Project T10/1760-D

Revision 14
28 January 2008

Information technology - Serial Attached SCSI - 2 (SAS-2)

Summary of Comments on Serial Attached SCSI - 2 (SAS-2) Standard

Figure 10 — SAS Domain class diagram

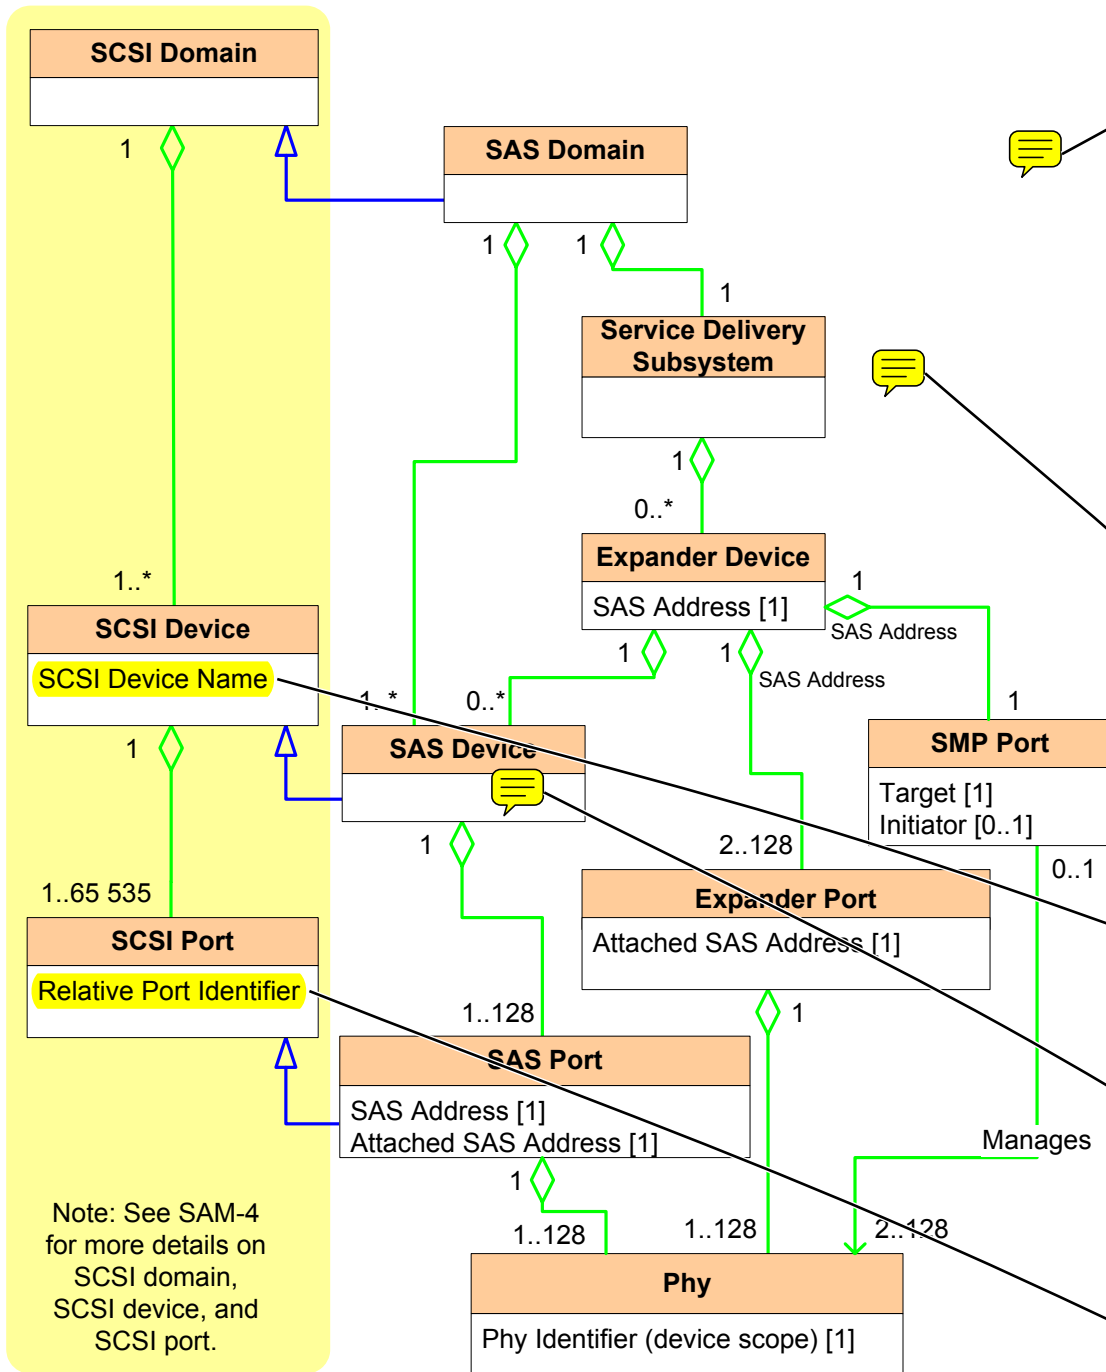
figure 10: changed 1..128 to 1..255

figure 10: changed 2.. to 2..255

Figure 16 — Port class diagram

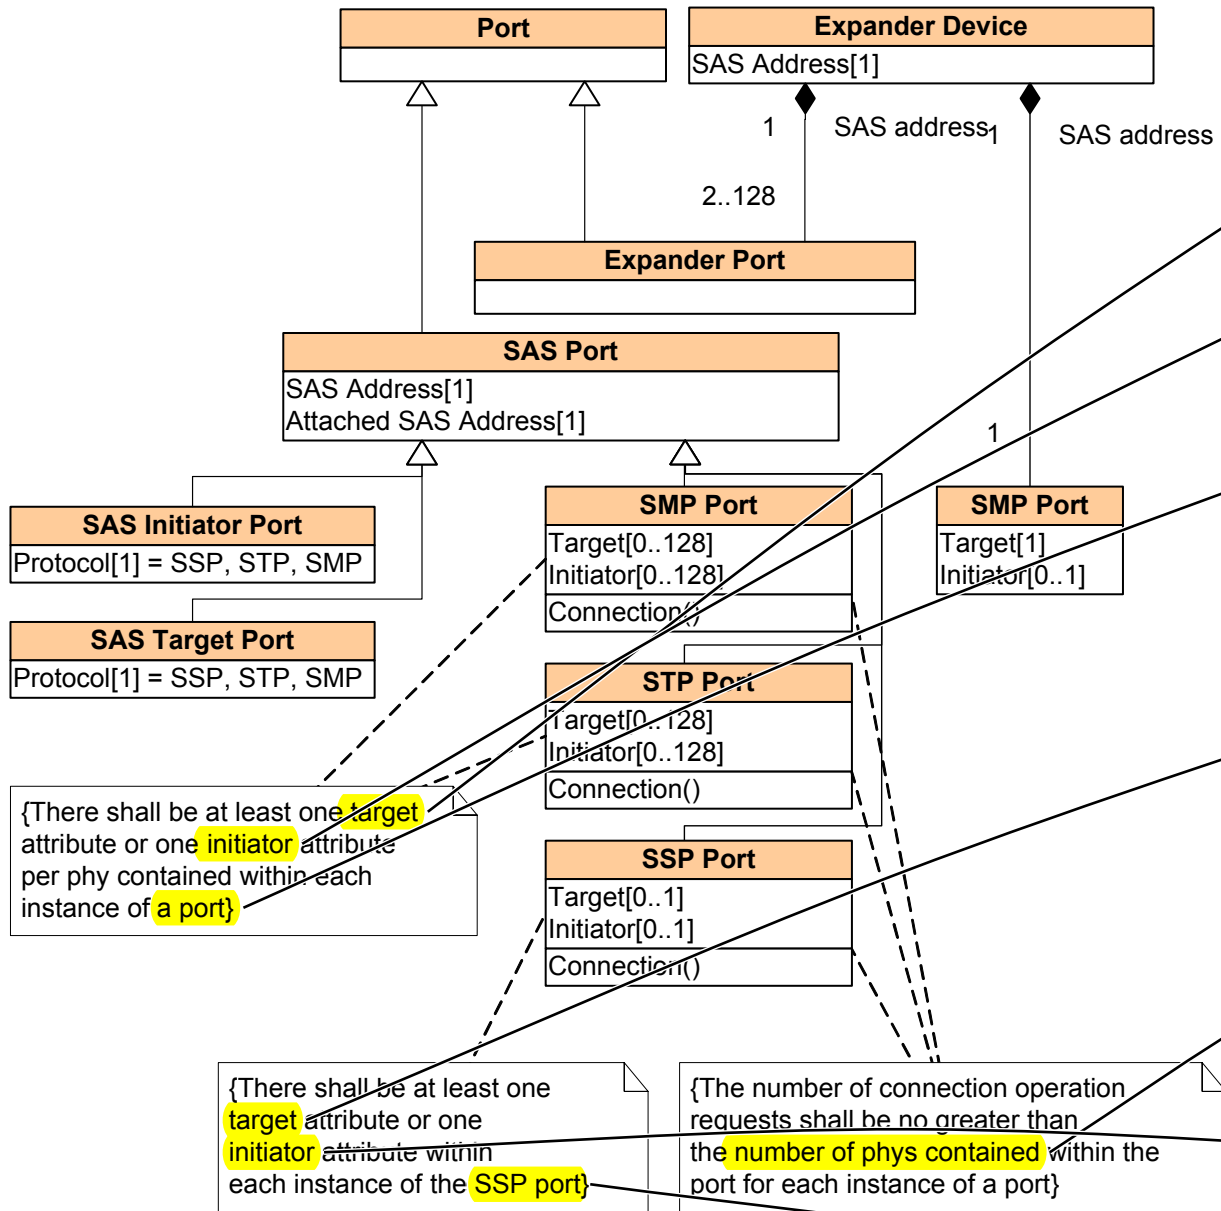
figure 16: changed [0..128] to [0..255] (zero to 255 possible phys)

figure 16: changed 2..128 to 2..255

Should be << detail is not shown. However, each port

Figure 28 — Multiple connections on wide ports

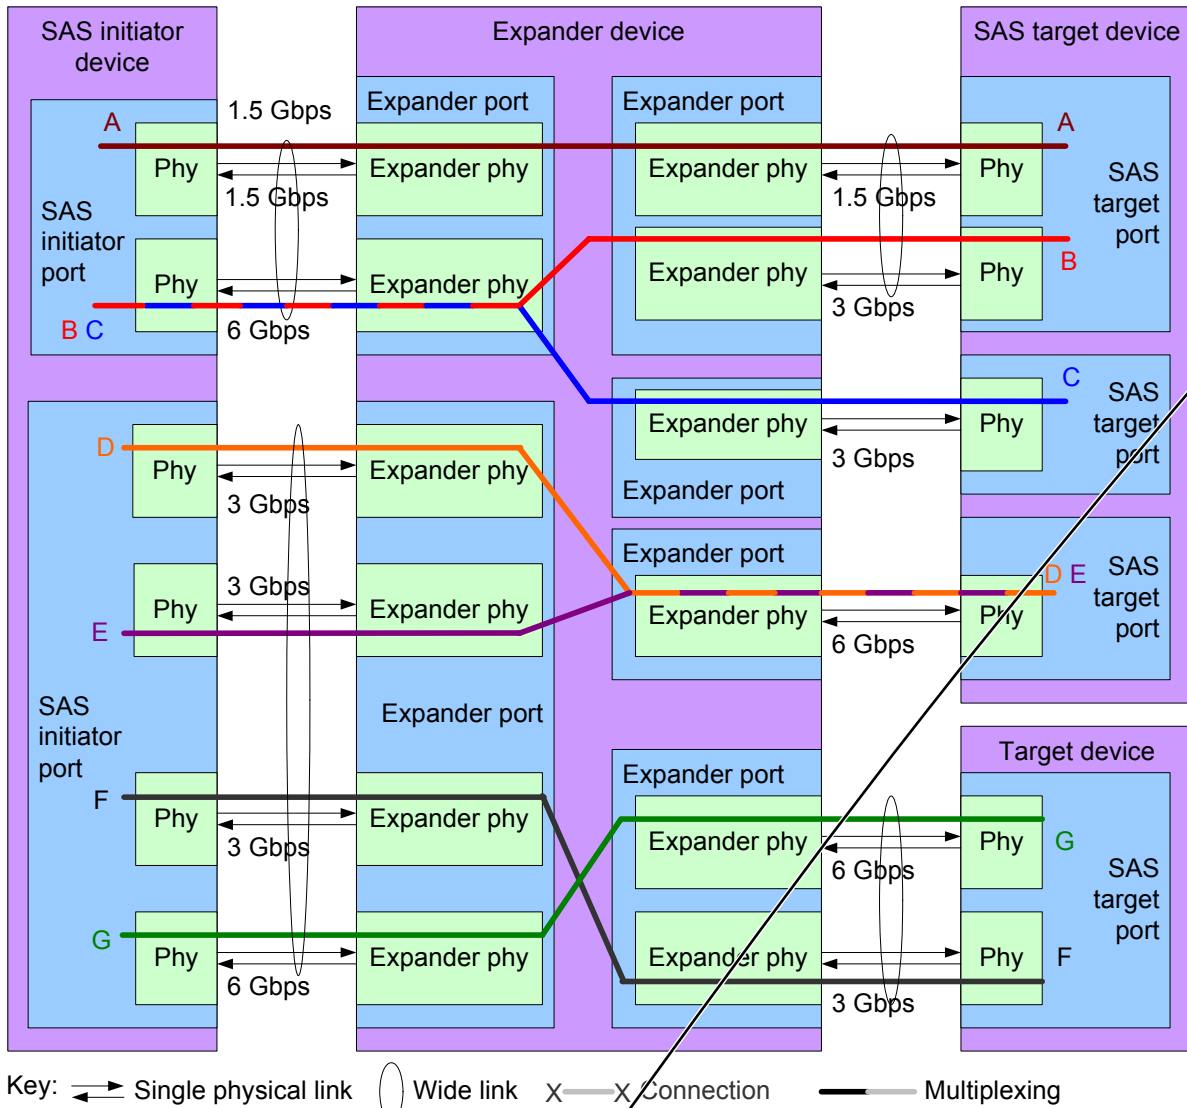
● Author: stx-goulder
Subject: Highlight
Date: 5/6/2008 4:07:48 PM

T ACCEPT - DONE (A, B, and C all originate from one initiator port, so should all be listed)
A and B

Figure 31 — Transmit data path in a SAS phy

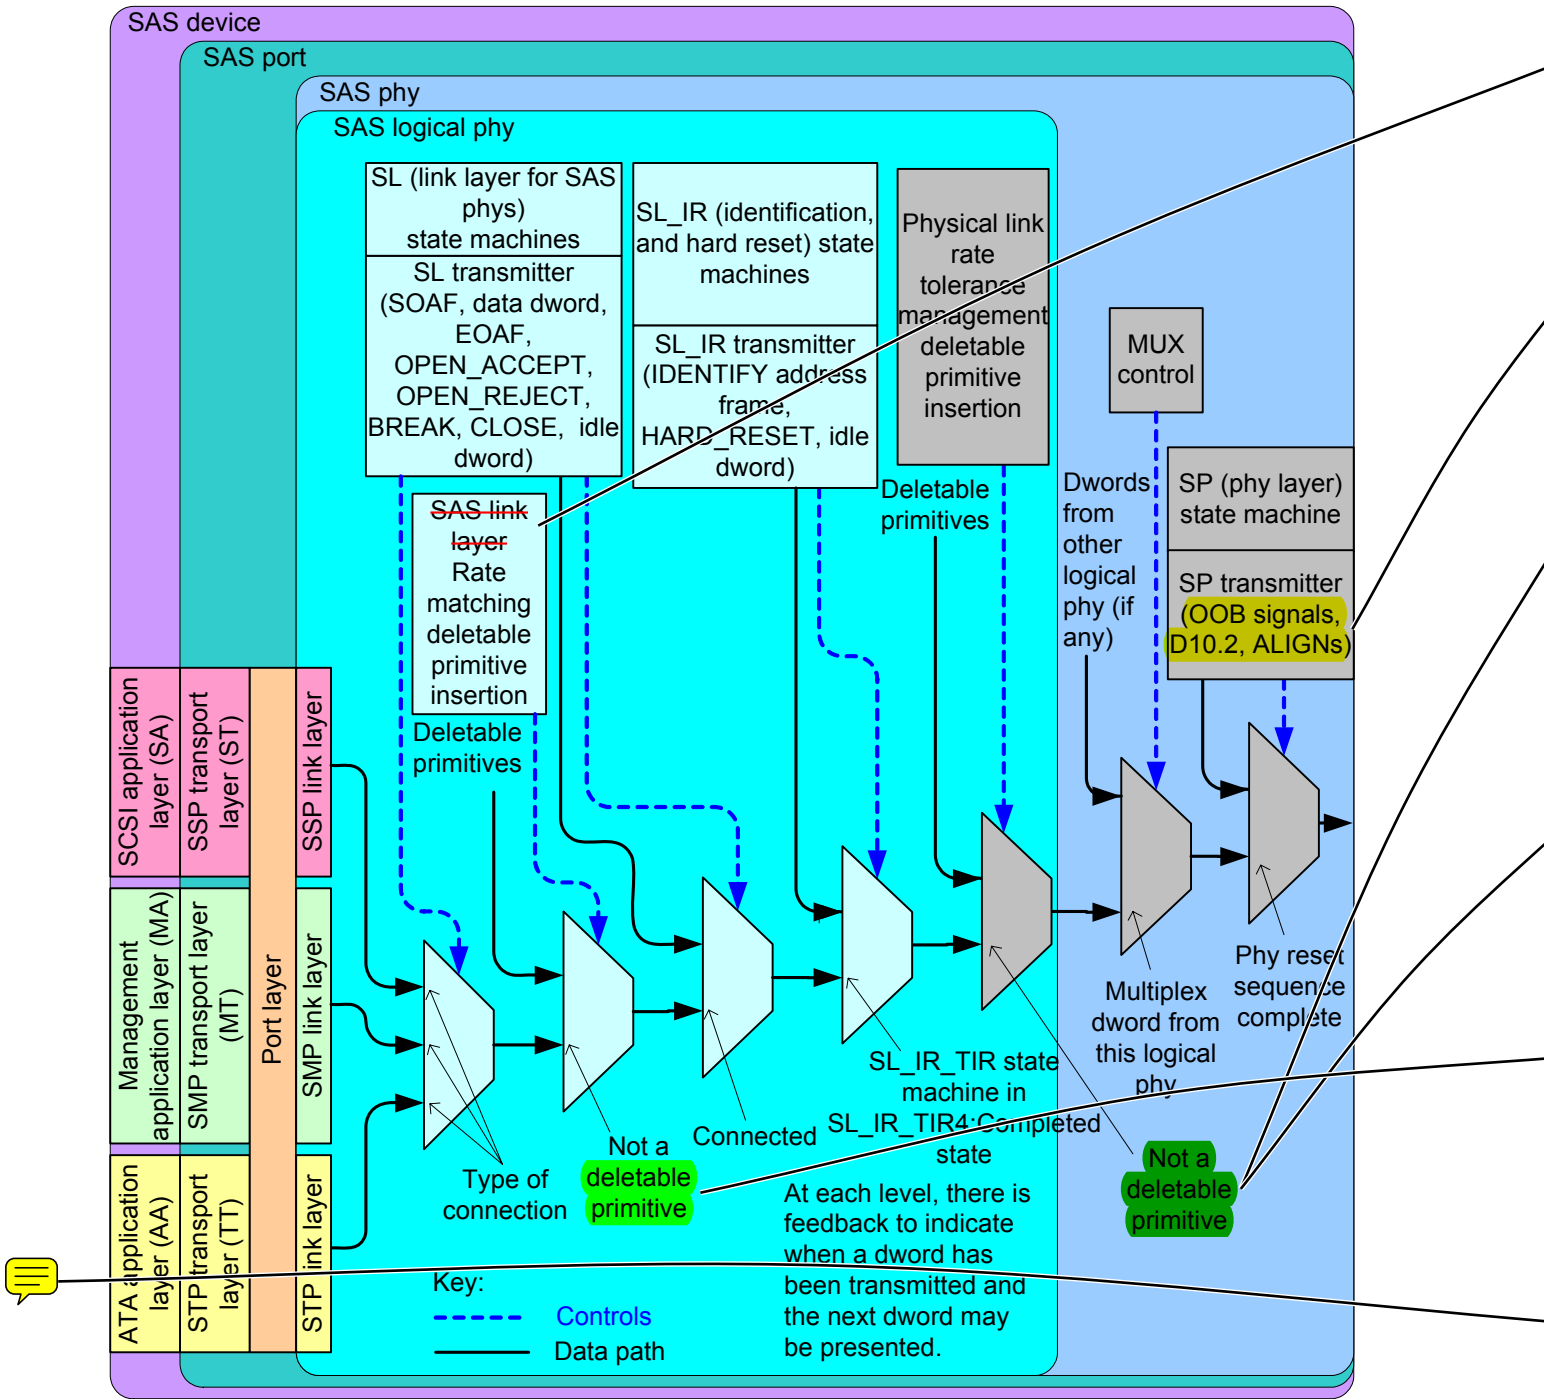
SL_IR state machine
s/b
SL_IR state machines

Figure 35 — Transmit data path and state machines in an expander phy

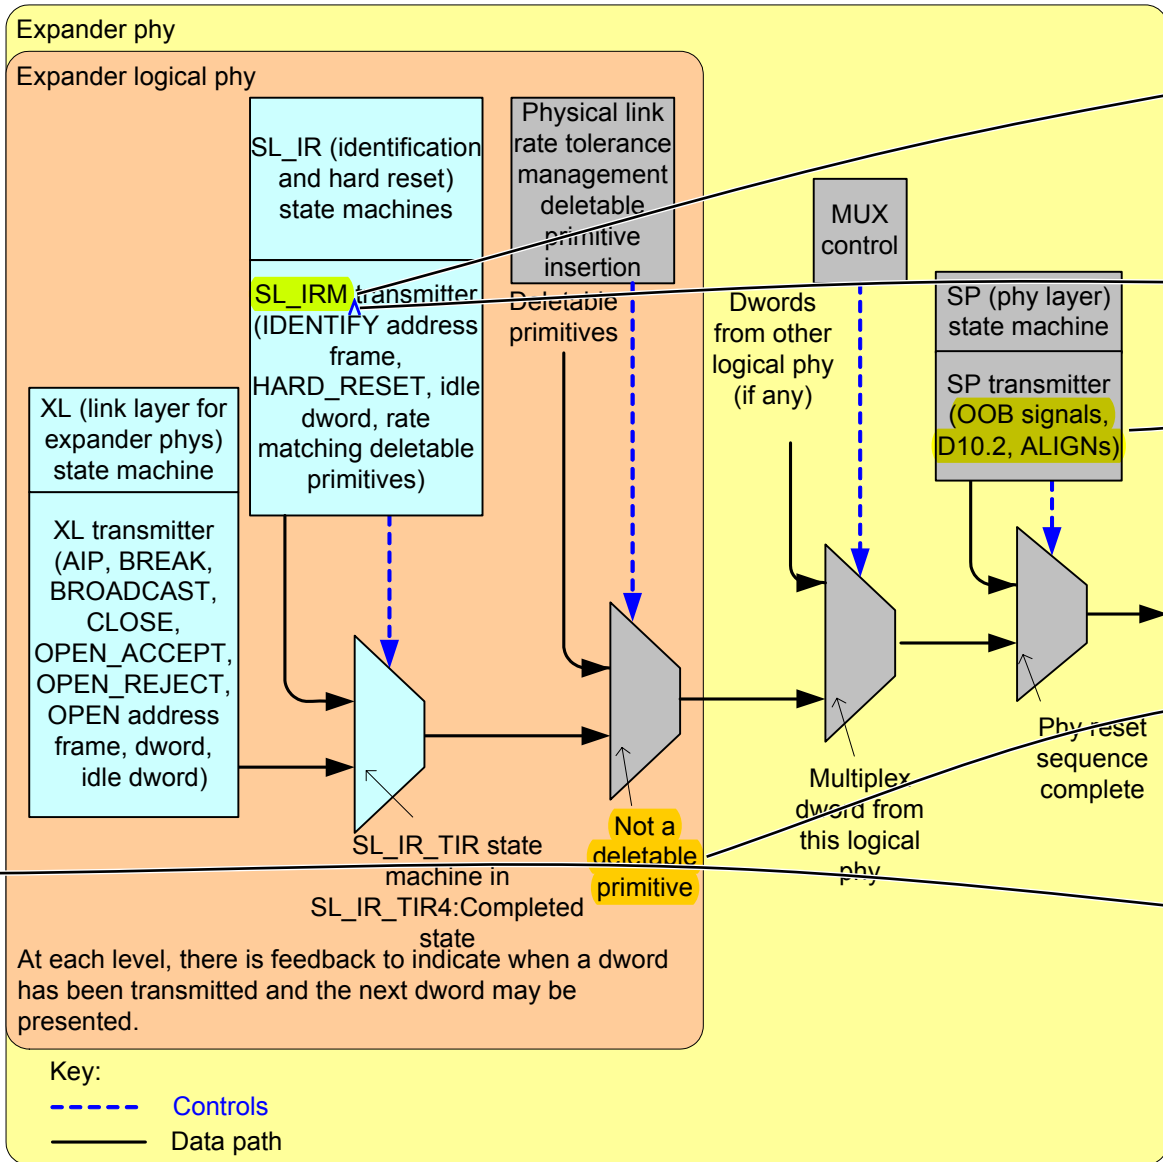
Add messages to figure 35 Receive data path:

Figure 38 — State machines and SAS Device classes

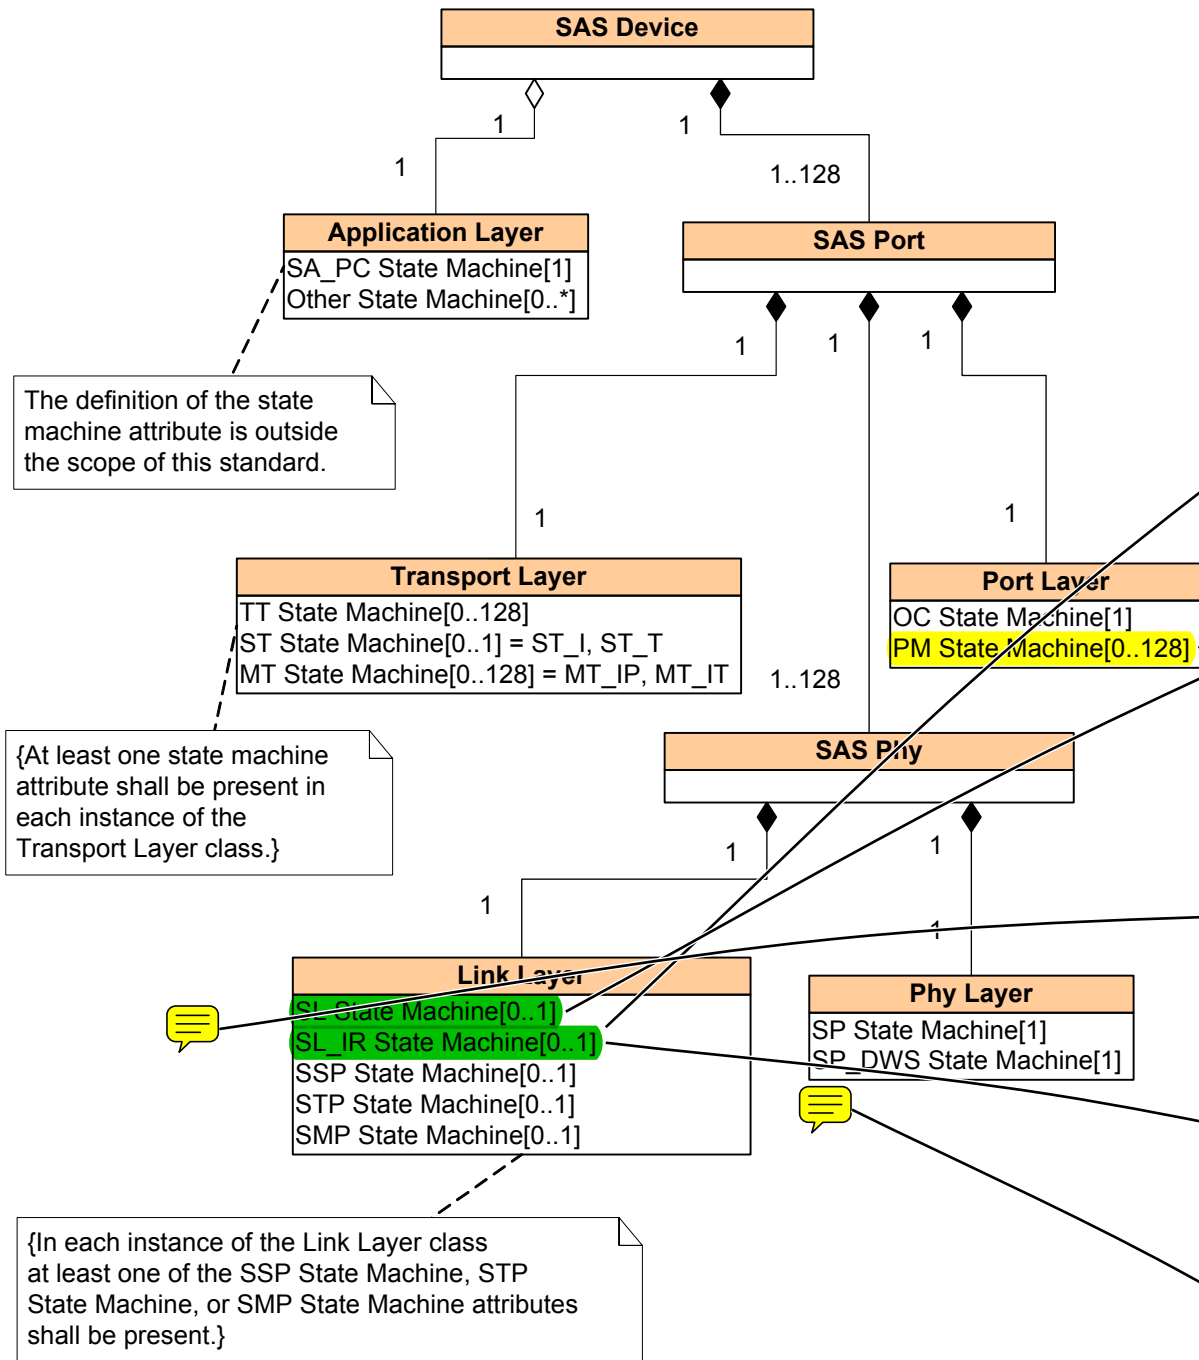
also figure 38: 0..128 to 0..255

also figure 38: 1..128 to 1..255

Figure 40 — Reset terminology

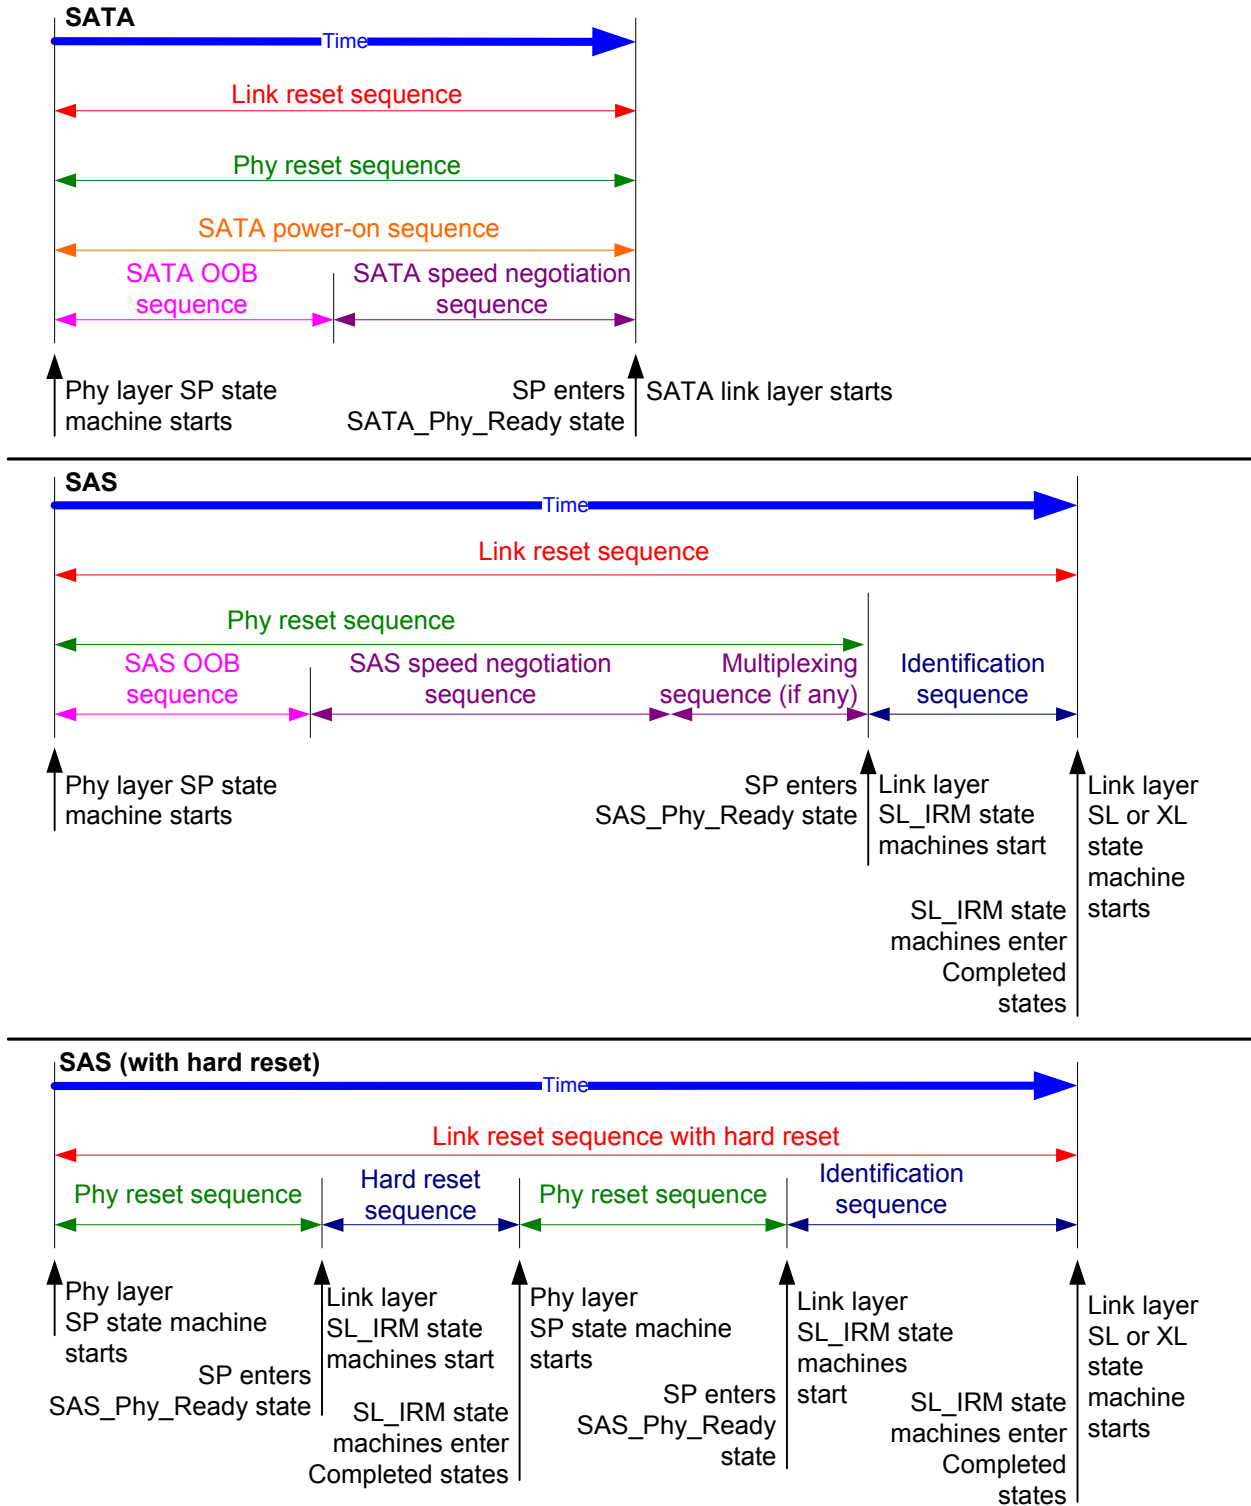
This figure does not show an SMP phy and associated link layer state machines below the SMP Port since figure 16 does not do so. If the expander allows more than one connection at a time to its SMP target port, then it's effectively a wide SMP port and has multiple phys and link layers. If it only allows one at a time, then it's effectively a narrow SMP port and only has one phy and link layer.
